Electron Dam Rock Dam Structure Status Report and Listed Species Take 5/17/2022

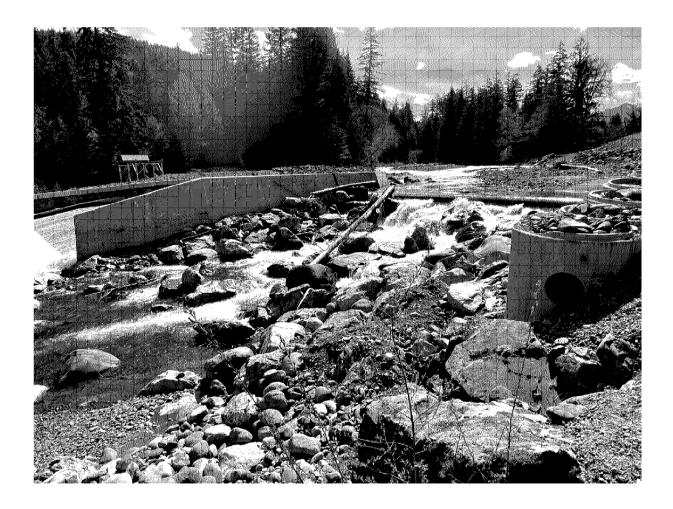
The area of large rock that was added downstream of the sheet pile dam has been stripped of all fine gravel, cobble and small rubble as predicted. What remains is highly angular boulders, with large voids that create an abrupt obstruction and provide little or no pool features that would allow for fish to stage a jump or to otherwise make successful passage upstream. While staging for successful passage is likely unavailable under current structure conditions, the flow over the rock dam continues to draw fish up into the structure to the point of the sheet pile, and they remain there prohibited from entering the fish ladder but also likely restricted from moving upstream. Once they are exhausted enough to potentially fall back, it is highly unlikely they will move laterally successfully to the fish ladder given the conditions downstream of the rock dam and turbulent conditions below the wood apron. Even if a fish could clear the required 6' vertical clearance at the steel sheet pile of the rock dam, while not impossible, is far from ideal much less desirable for a facility whose fish passage systems have been repeatedly called into question.

The rock dam feature now works in concert with the sheet pile flow over the wooden dam apron. This collective stream of water will act to confuse, disorient and exhaust all species in their quest to fish upstream passage.

The fact that so much flow goes over the sheetpile dam contributes to the attraction of upstream migrating fish. This very effectively leads to their exhaustion, injury and in all likelihood reduces their chances at reproducing successfully.

The rock dam itself is a barrier to fish passage, the increased height of the steel structure, which was not installed as permitted to begin with, now completely blocks fish passage, but the rock itself has once again moved during winter flows. So, once again, fish are drawn up river left with nowhere to go and will be stranded in the offset portion of the structure.

In addition to the continued problem on the left bank, now the flow over the wood crib structure has created a high velocity and turbulent condition which is naturally more attractant to fish and is highly likely encumbering fish from finding the fishway entrance. This makes it VERY unlikely fish will find the fish ladder even on the right bank. Based on our most current steelhead surveys of the mainstem bypass reach (≈6.2 miles), and all surveyed reaches above Electron (≈10 miles), only 8% of estimated adult steelhead successfully migrated upstream of the Electron Dam. During the 2021 steelhead run, an estimated 21% of adult steelhead successfully migrated upstream of the Electron Dam.
